ADDENDUM No. 002

Subject: Roof Replacement
SDP Contract No. **B-046C of 2017/18** General Construction

Location: T. Creighton School
5401 Tabor Avenue
Philadelphia, Pennsylvania 19120

PROJECT CREIGHTON SCHOOL ROOF REPLACEMENT	JOB # B046C OF 2017/18	DRAWING # SK120219C	REVISION 1
	DRAWN BY: CJN	DATE: 12/1/19	SCALE: 1 = 1 1/2" = 1' - 0"
SUBJECT DETAIL AT ROOF DRAIN		DRAWING REF. A3

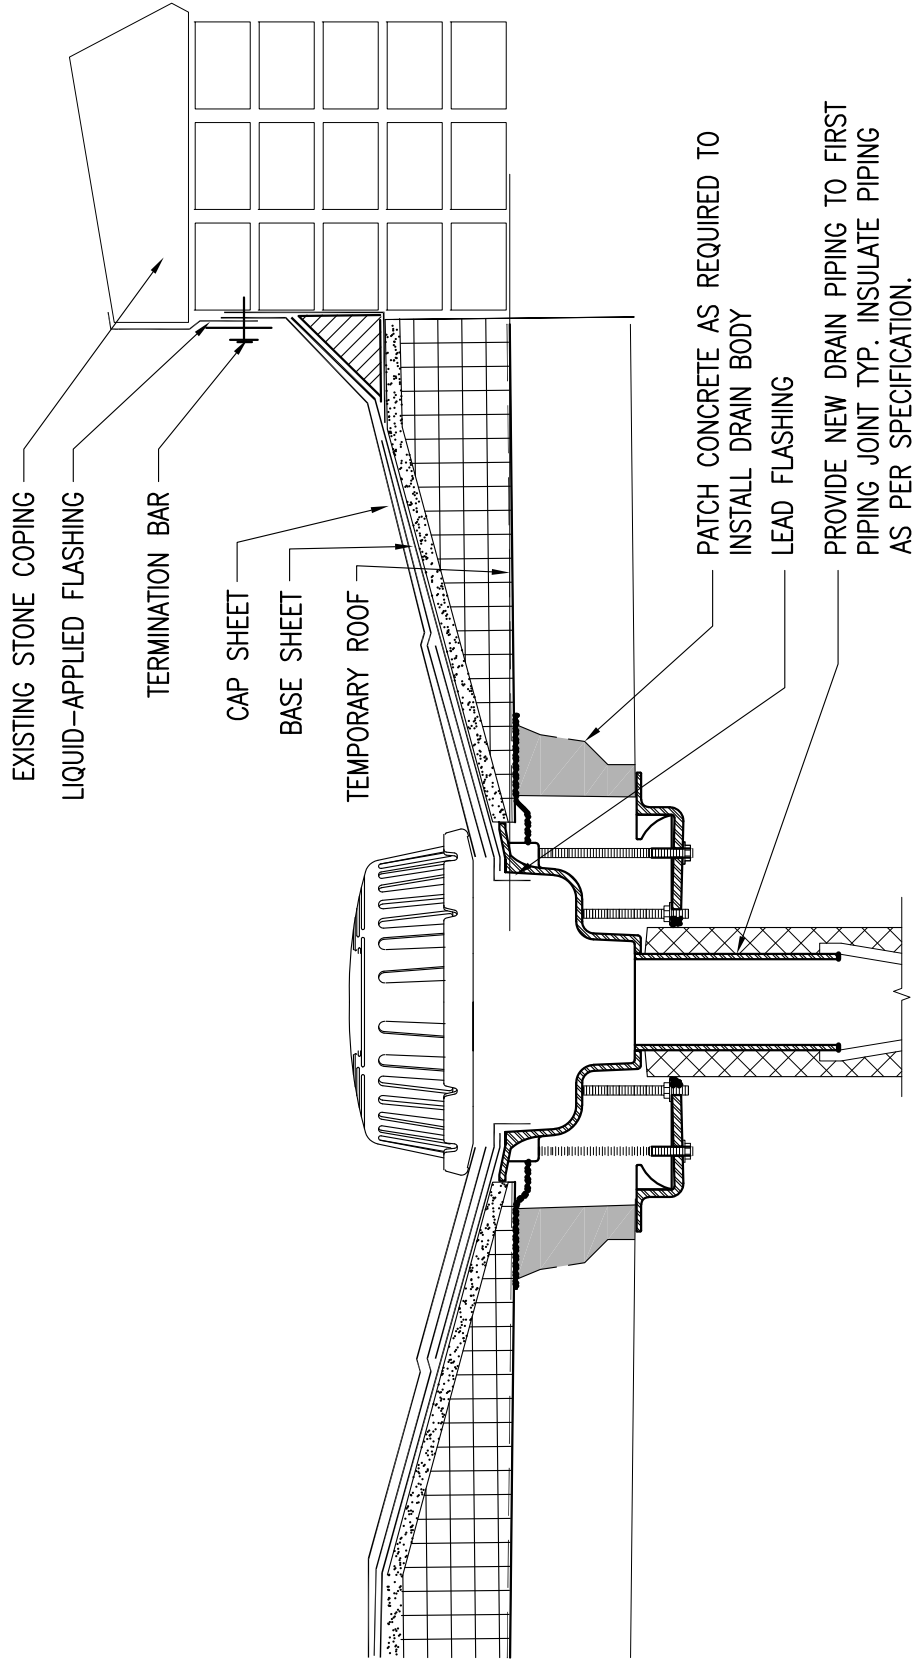
- a. Bid form shall remain. Concrete deck repair is not expected to include rebar repair or replacement.
 7. Detail 8/A3 shows metal coping. Will any areas get metal coping?

3. On detail 8/A3, you show coping but on the same roof, just the other side you show no coping. Please know this would be very hard to do, and almost impossible to keep water tight.

- a. Refer to attached SK120219C. Delete metal coping and provide termination bar and liquid-applied flashing as required for low-rise flashing heights.

- a. Refer to attached SK120219C. Delete metal coping and provide termination bar and liquid-applied flashing as required for low-rise flashing heights.

DETAIL AT ACCESS DOOR SILL
SCALE: 1-1/2" = 1'-0"

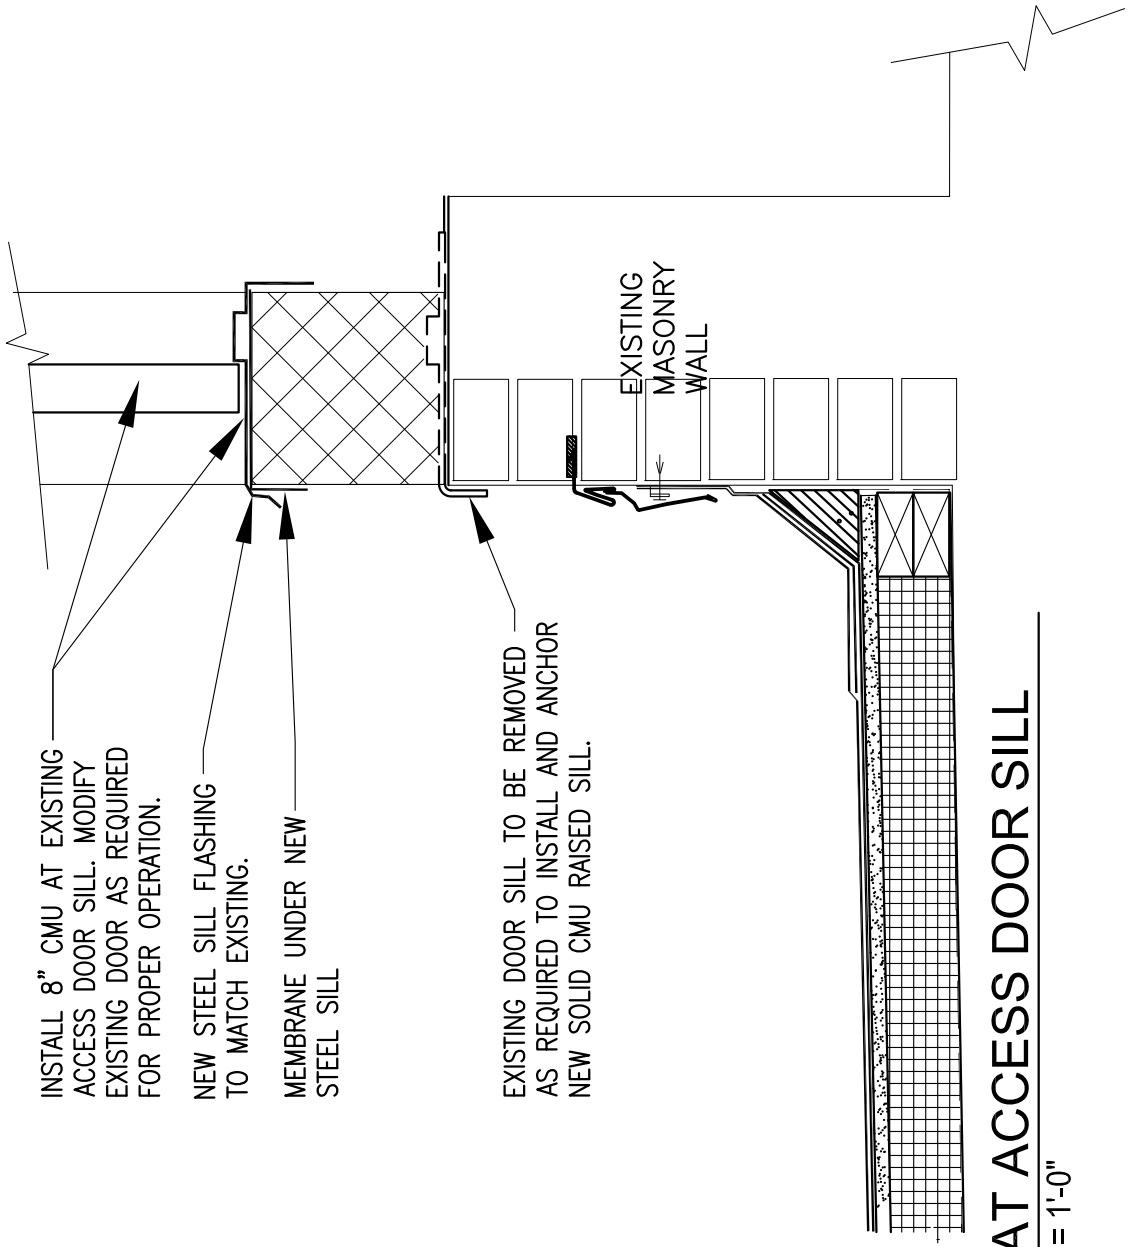
1. Add Detail 12/A3 Detail at Access Door Sill. Raise door sill and modify door as required to operate. Refer to attached SK120219D.

INSTALL 8" CMU AT EXISTING ACCESS DOOR SILL. MODIFY EXISTING DOOR AS REQUIRED FOR PROPER OPERATION.

EXISTING DOOR SILL TO BE REMOVED AS REQUIRED TO INSTALL AND ANCHOR NEW SOLID CMU RAISED SILL.
